**Re: Eden Oaks Subdivision
Town of Halton Hills
Project No.: 300038991.0000**

**Re: EDEN OAK (CREDITVIEW HEIGHTS) INC.
2-Tier Pond Grading
SUBDIVISION 24T-08001 / HH
Town of Halton Hills (Georgetown)
C. E. File No: 08-010**

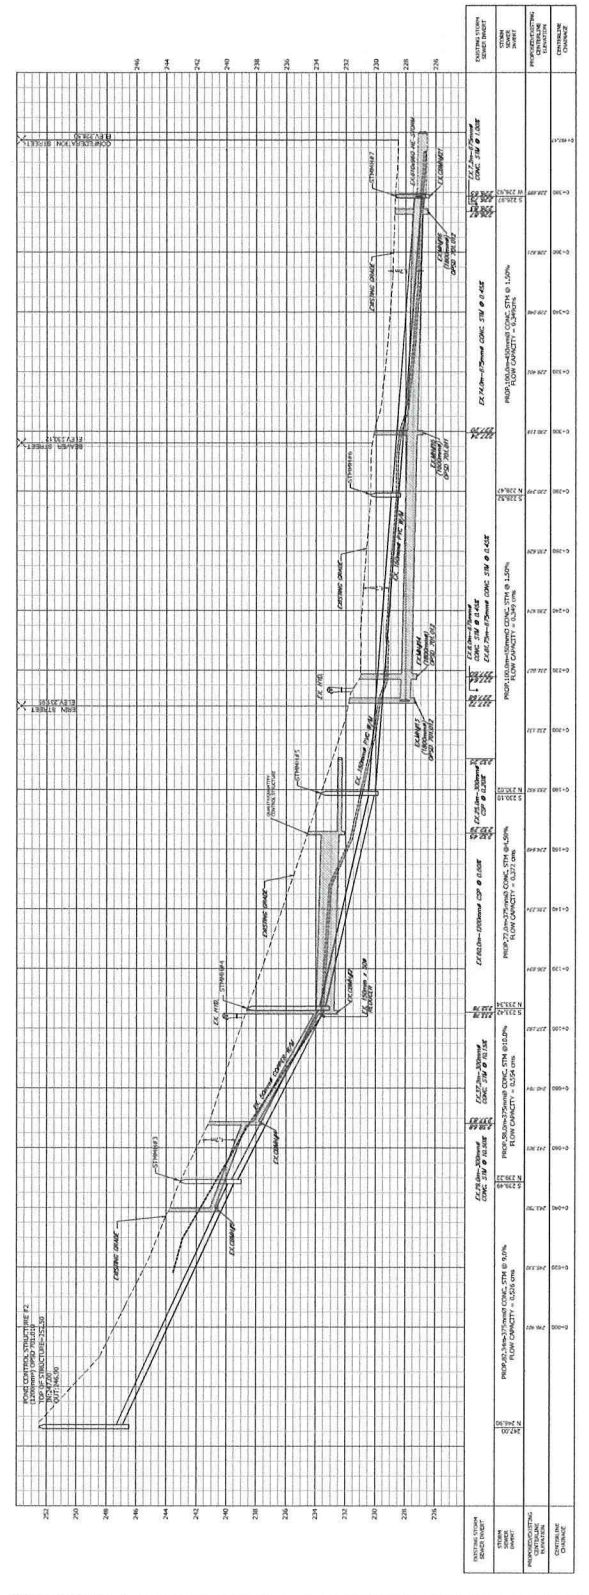
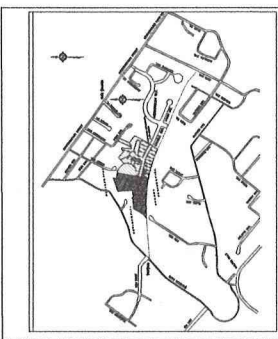
3. It was confirmed in the meeting of February 15, 2017 that all of the outflow designed to discharge from the upper pond will be conveyed to the lower pond via piping. There will be a spillway provided for emergency use only as an additional precaution against washout.
4. Conveyance of flows on Credit Street was a concern as we required certainty that the creation of a new outlet would not impact on any adjacent properties under any circumstance. Our letter of January 17, 2017 suggested that the Regional discharge from the Eden Oak pond be conveyed in an independent storm sewer to a suitable discharge location situated within the Regional floodplain. That suggestion was accepted by Eden Oak and a profile for the independent storm sewer was included in the submission of February 1, 2017.

4. We have provided a profile plan (attached) of Credit road that shows our proposal to "pipe" the Regional Storm event to the flood plain per our conversation.

TOWN OF HALTON HILLS
ENGINEERING DEPARTMENT
POND CROSS-SECTIONS
FIGURE 7-A

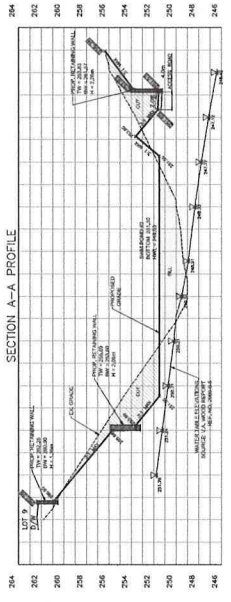
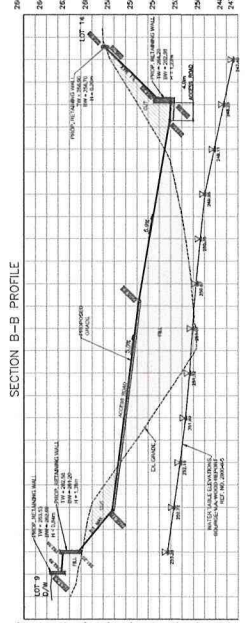
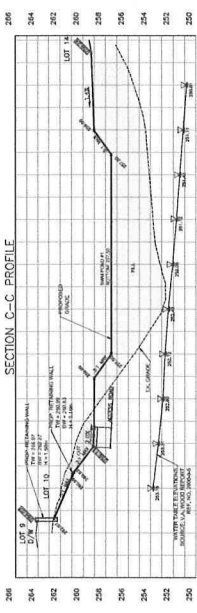
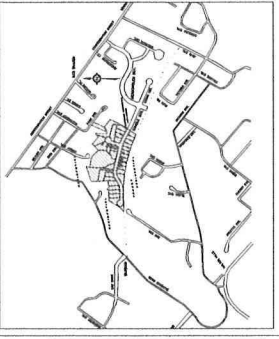
2. The shape of the ponds and their fit to natural contours was a concern. Discussions with V.A. Wood Associates, geotechnical engineers, provided assistance in selecting a grading design that maximized the pond stability. The letter from Condeland Engineering dated February 20, 2017 commits to a substantial lowering of each pond. We have agreed that these revisions can be finalized at the time of final design, following a detailed site survey and additional geotechnical work in the pond area. With the proposal from Condeland we are satisfied that the pond design now fits well into the existing terrain.

We have completed the lateral cross sections across the pond and have included the "critical" grades of the lots at the edges of the pond and along the trail. The elevation along the ponds have been reviewed and lowered as much as possible. The trail grade averages 6.0% to Credit Street. There are opportunities to lower the pond in some areas maintaining the current critical grades, however, any further lowering of the pond would depend on a higher acceptable height of retaining wall and a steeper gradient along the trail.
